*Reviewed on
6/3/96 by A. Leech
See letter dated 6/3/96*

Re: 16525 Worthley Drive
San Lorenzo, CA

Subject: Proposed Workplan to Assess the Presence of Gasoline and BTEX Contamination Down Gradient of the Reported Source Area for Property Located at 16525 Worthley Drive, San Lorenzo area of Alameda County

EPIGENE INTERNATIONAL	Project # 16525 WORTHLEY DRIVE, San Lorenzo, Alameda Co., Calif
Fig. 2 PROPOSED HYDROPUNCH LOCATIONS

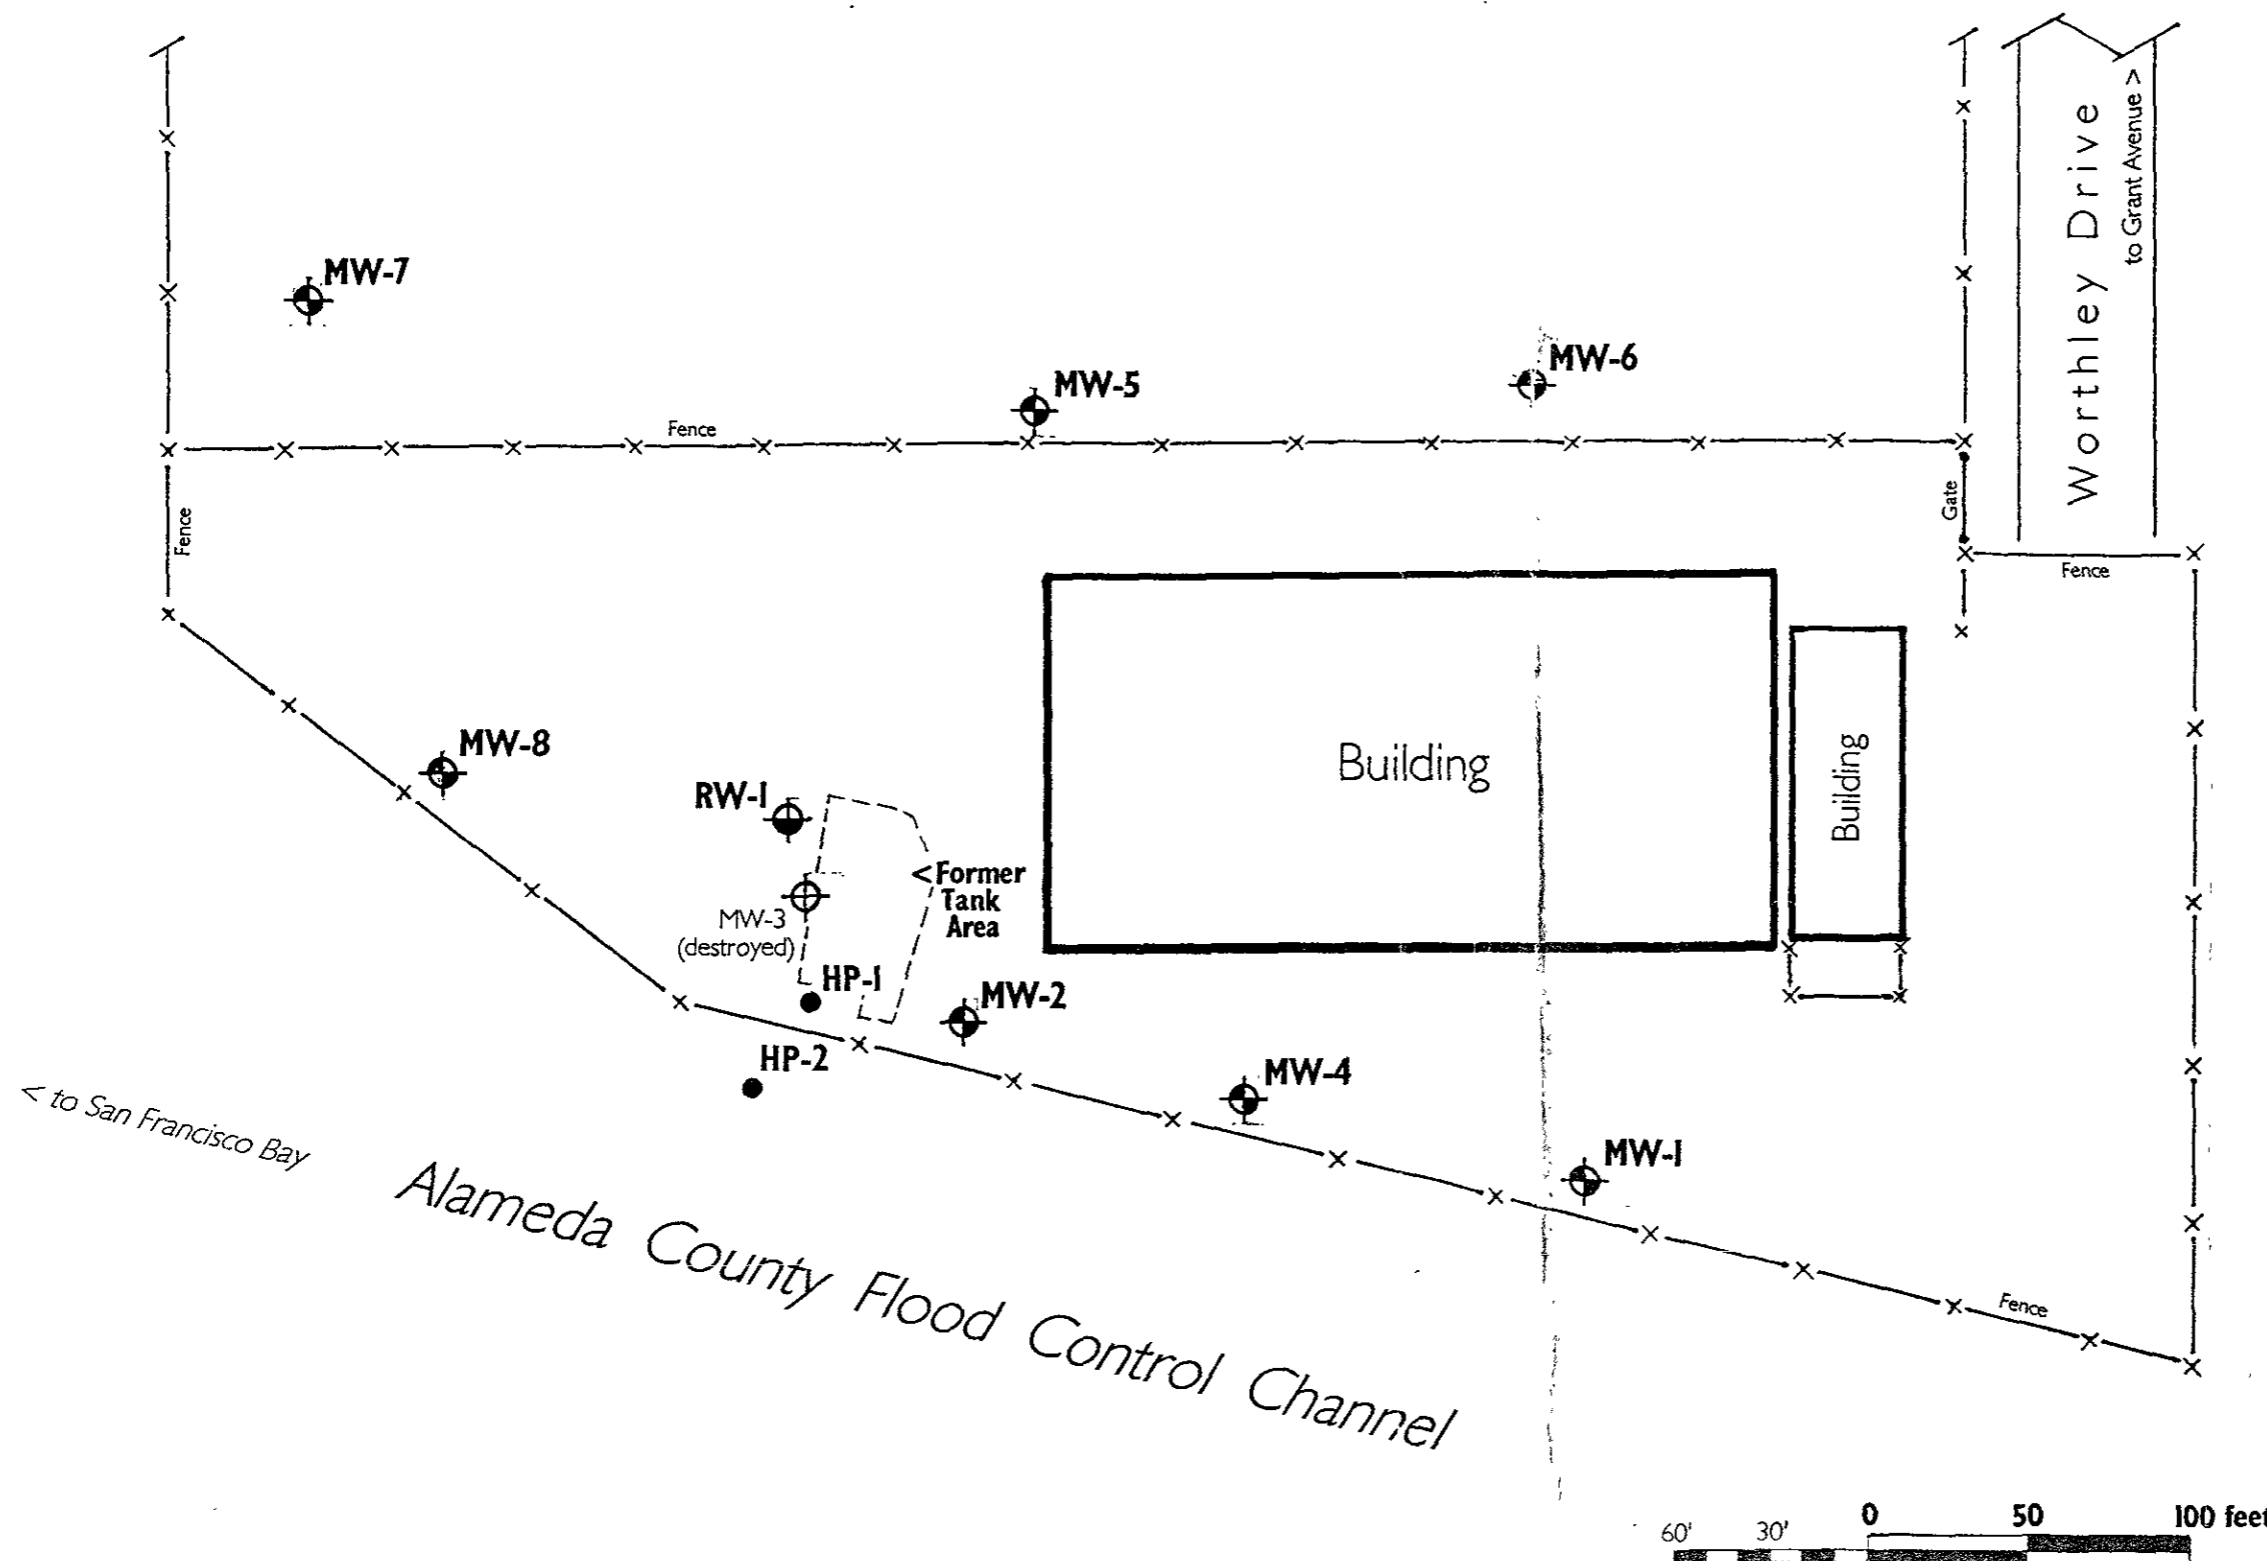
→ Soil/gw interface

→ Also MTBE!
